# UNITED STATES PATENT AND TRADEMARK OFFICE

APPLICATION NO.	FILING DATE	FIRST NAMED INVENTOR	ATTORNEY DOCKET NO.	CONFIRMATION NO.
10/791,484	03/02/2004	Giancarlo Cassarino	930026-2017	1887

<b>Office Action Summary</b>	Application No. 10/791,484	Applicant(s) CASSARINO, GIANCARLO	
	Examiner Gary L. Welch	Art Unit 3765

## DETAILED ACTION

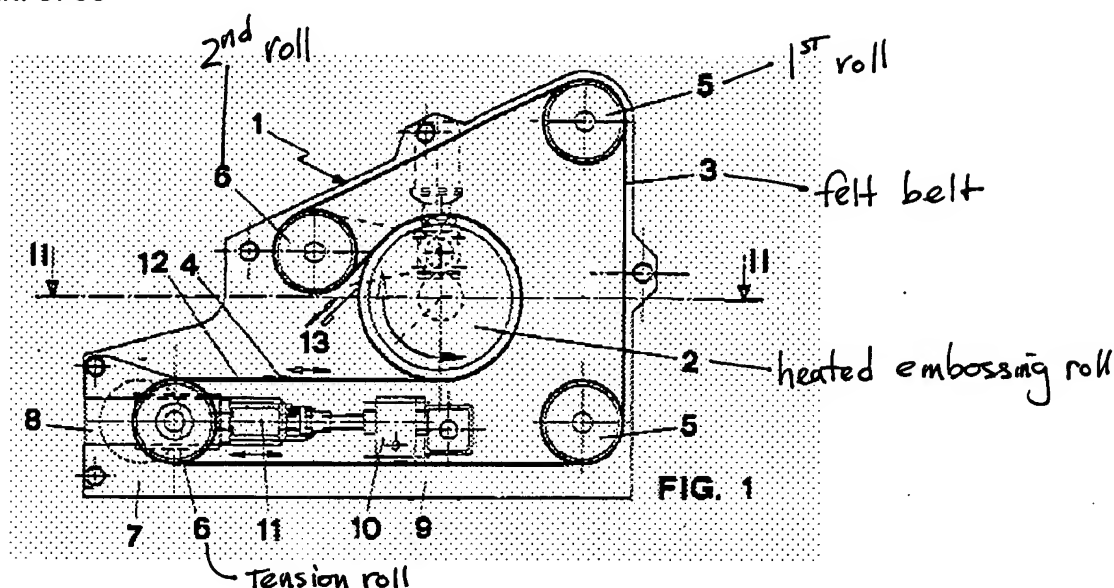
Bergozza discloses an apparatus for use in a leather industry for embossing leather textiles. The apparatus has first and second rolls, a heated embossing roll 2 operable to have the leather textile 4 wrapped around at least a portion thereof, a tension roll and a felt belt 3 operable to be wrapped around at least a portion of the tension roll and the first and second rolls and over the leather textile wrapped around the embossing roll. The apparatus is operable to enable the leather textile 4 to be conveyed around the embossing roll between the felt belt and the embossing roll so as to be embossed (see figure below).

However, Bergozza does not disclose that the felt belt is under tension in the range of 10-500 N/mm.

A review of the applicant's disclosure does not reveal any criticality for this claimed limitation (i.e., why 10-500 N/mm is better than any other value).

Therefore, it would have been obvious through routine experimentation to determine the optimum value(s) in tensioning the felt belt 3 so as to ensure successful embossing of the leather (Col. 3, lines 22-26).

With regard to claim 2, the first and second rolls, the tension roll and the embossing roll 2 are arranged so as to not to form a nip between any two rolls.

With regard to claim 3, each of the first and second rolls, the embossing roll 2 and the tension roll are cylindrical in shape.

With regard to claims 4 and 9, the felt belt 3 has a high thermal, chemical and mechanical resistance and is permeable to fluid (Col. 3, lines 52-54). The claim language does not define what the applicant considers as high thermal, chemical and mechanical resistance. Additionally, it is reasonable to believe that the

With regard to claims 5 and 10, the embossing roll 2 and the felt belt 3 is a texturing medium.
